New Albany Architectural Review Board Meeting Agenda
Monday, December 11, 2023 7:00 p.m.

ARB-106-2023 Certificate of Appropriateness

Certificate of Appropriateness to construct six new townhomes along Richmond Square located generally north of Main Street, south of McDonald Lane, and west of Keswick Drive (PID: 222-000043).

New Albany Architectural Review Board
DRAFT Meeting Minutes
Monday, November 13, 2023 7:00 p.m.

Main Street:

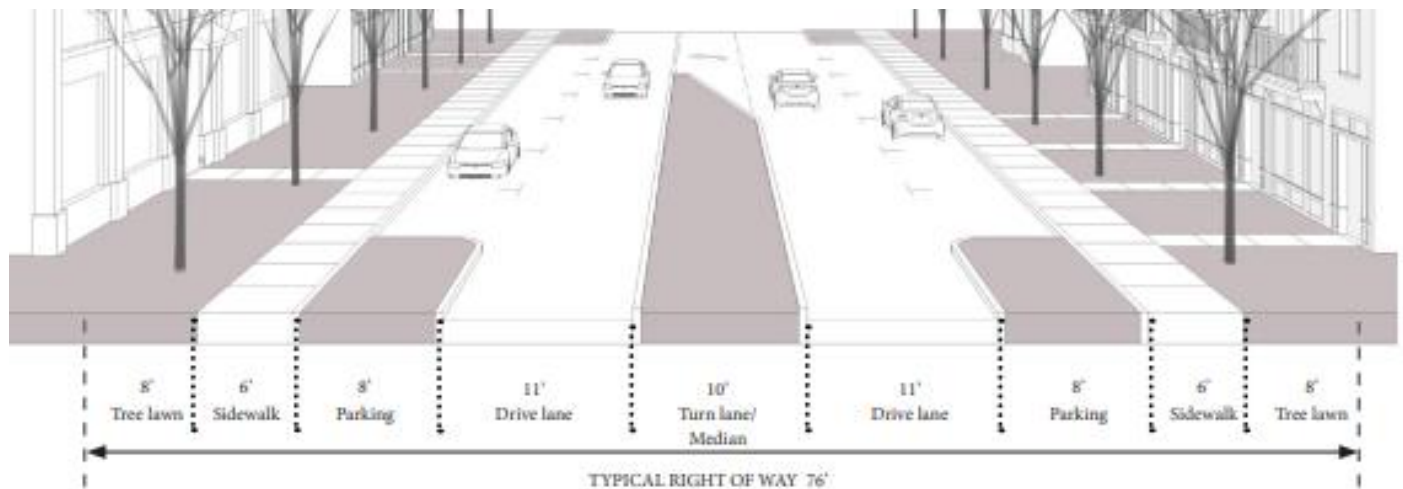
- This original streetscape was approved by the ARB and by staff in accordance with Urban Center Code Section 5.2.1 (ARB-31-2016). This includes the sidewalks, tree lawns, front yards, and on-street parking.
- Urban Center Code Section 5.1 identifies this section of Main Street at Village Street. The following standards apply:

- The applicant proposes to meet all of the width and tree spacing requirements for the streetscape. The proposal flip-flops the location of the sidewalk and the tree lawn in order to match the existing residential design that the ARB approved in front of the apartment buildings on Main Street.

- The city has always placed an importance of undergrounding utilities and their appurtenances whenever possible especially in the Village Center. There are 3 existing utility boxes that are installed within the Main Street streetscape. If these utilities are relocated or vaulted underground, it appears that there is sufficient space to add an additional on-street parking space. Staff recommends a condition of approval that these existing utility boxes are either installed underground or relocated to behind the existing sidewalk on Main Street, subject to the city's engineer's approval (condition #8).

Richmond Square and Keswick Drive:

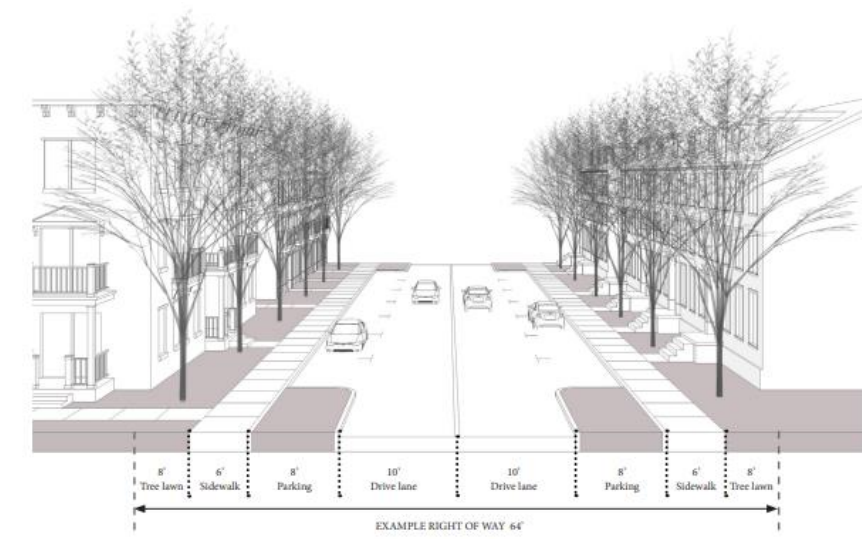
- Urban Center Code Section 5.1 identifies Richmond Square and Keswick Drive as a Village Avenue. The following standards apply:

Standard	Minimum	Maximum	Proposed
Tree Spacing	25'	25'	25' [proposed and meets code]
Tree Lawn	6'	8'	14' [proposed, <u>Staff recommends a condition of approval that the plans be updated to meet this code requirement (condition #10) by shifting the sidewalk closer to the street so there is an 8-foot-wide tree lawn.</u>
Sidewalk Width	6'	8'	5' [proposed] <u>Staff recommends a condition of approval the side is a minimum of 6 feet wide.</u>
Parking Width	8'	8'	No on-street parking is proposed in order to match the existing street typology established by the apartments and Keswick subdivision. Staff is supportive and recommends the tree lawn be 8 feet to accommodate the possibility of future on-street parking.
Drive Lane Width	9'	10'	13' [existing and approved by ARB via Keswick application]
Turn Lane Width	-	-	-
Total R.O.W	58'	64'	50 feet

10. The plans shall be updated to provide a 6'8-foot-wide tree lawn along Keswick Drive.
11. The plans shall be updated to clarify whether the covered stoops meet code.

1 ENLARGED SITE PLAN
1" = 50'-0"

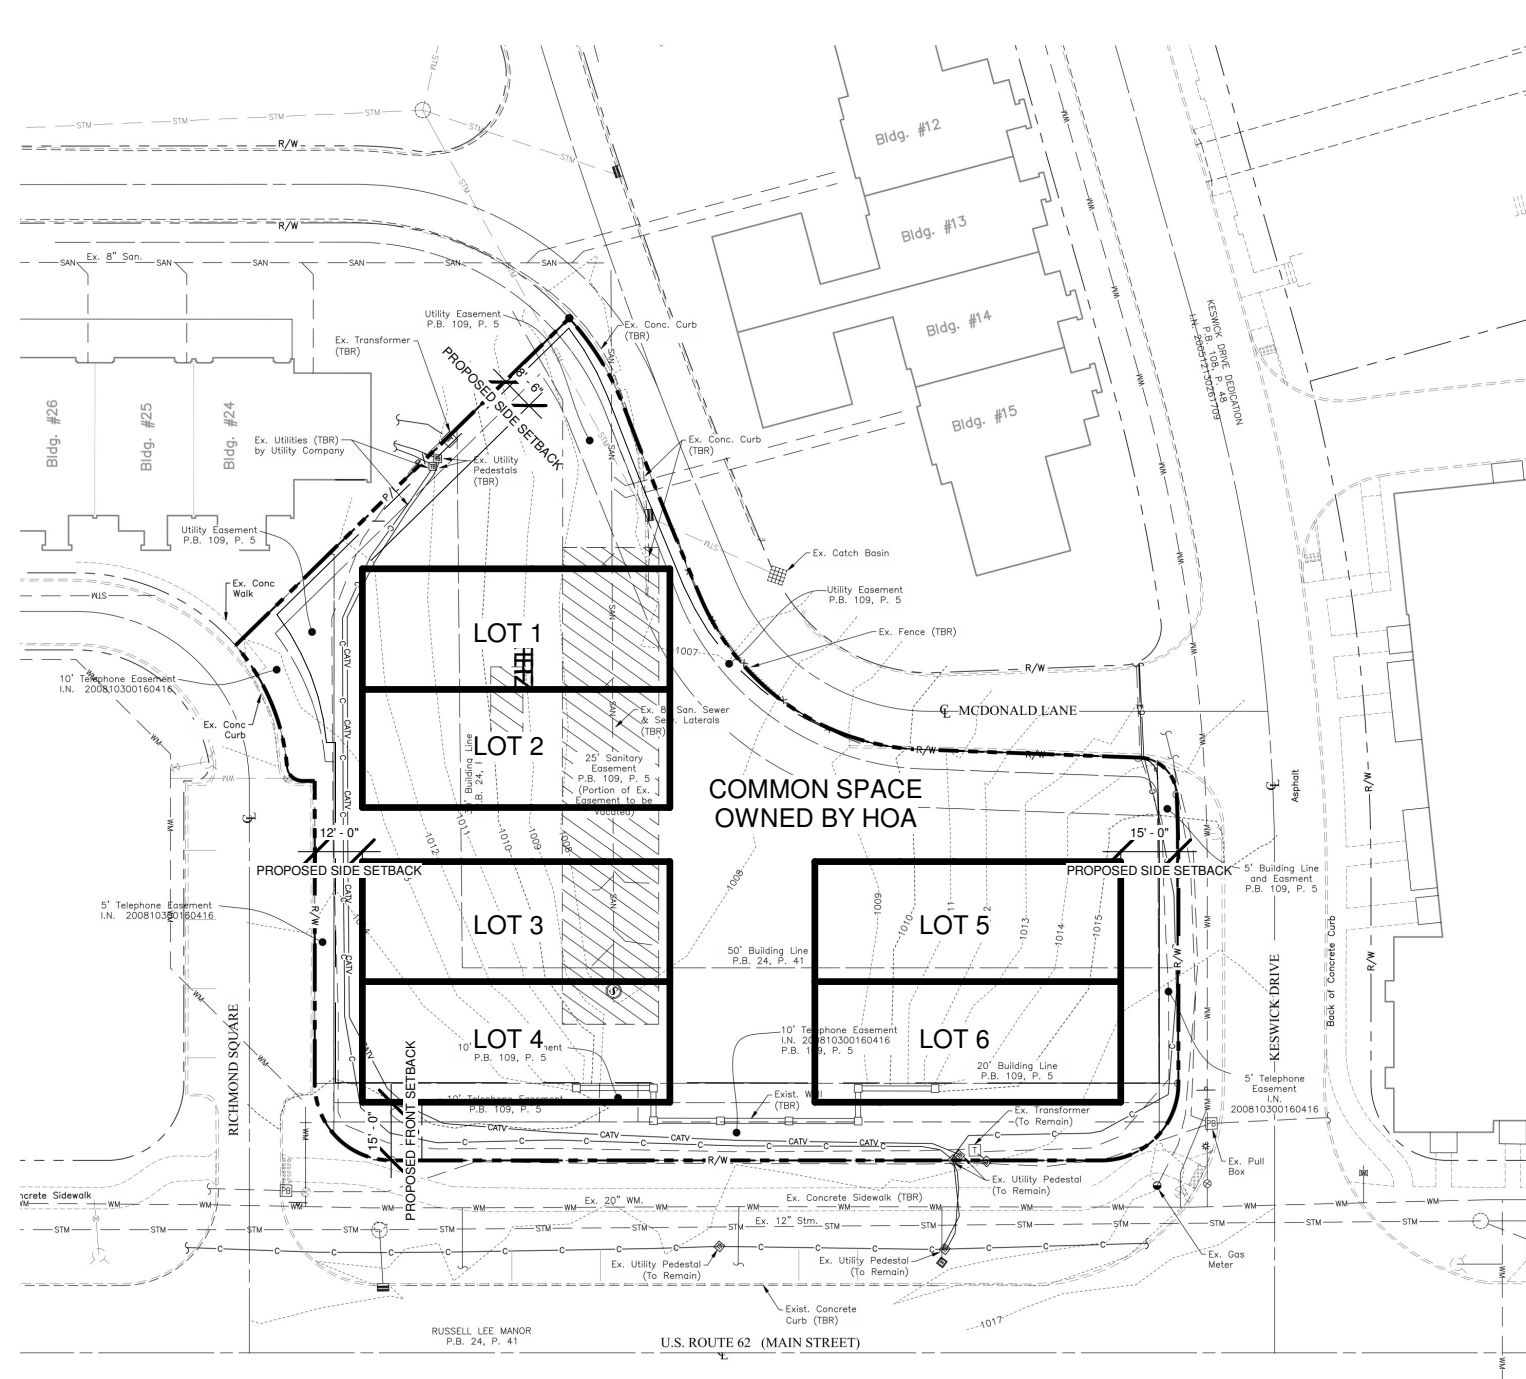
- c. Street trees species shall match the adjacent block unless the adjacent street typology differ.
- Some landscaping is shown on the site plan that shows the general location of proposed landscape improvements for the site but does not include any size or species details. Since a detailed landscape plan was not submitted, staff recommends a condition of approval that it be subject to staff approval and that all landscape code requirements be met for the site (condition #4).

- Per Urban Center Code Section 5.30.3, one bicycle parking space is required to be provided on site based on the number of off-street parking spaces. The plan does not currently show bike racks. Staff recommends a condition of approval that the plans be updated to include the required number of bike racks on private property, subject to staff approval (condition #6).

4. A landscape plan must be submitted and meet all city landscape code requirements, subject to staff approval.
5. A lighting plan must be submitted and is subject to staff approval.

9. The plans shall be revised to clearly indicate the proposed sidewalk is 6-foot wide along Richmond Square and Keswick Drive, connecting into the existing sidewalk sections along both Richmond Square and Main Street, subject to staff approval.
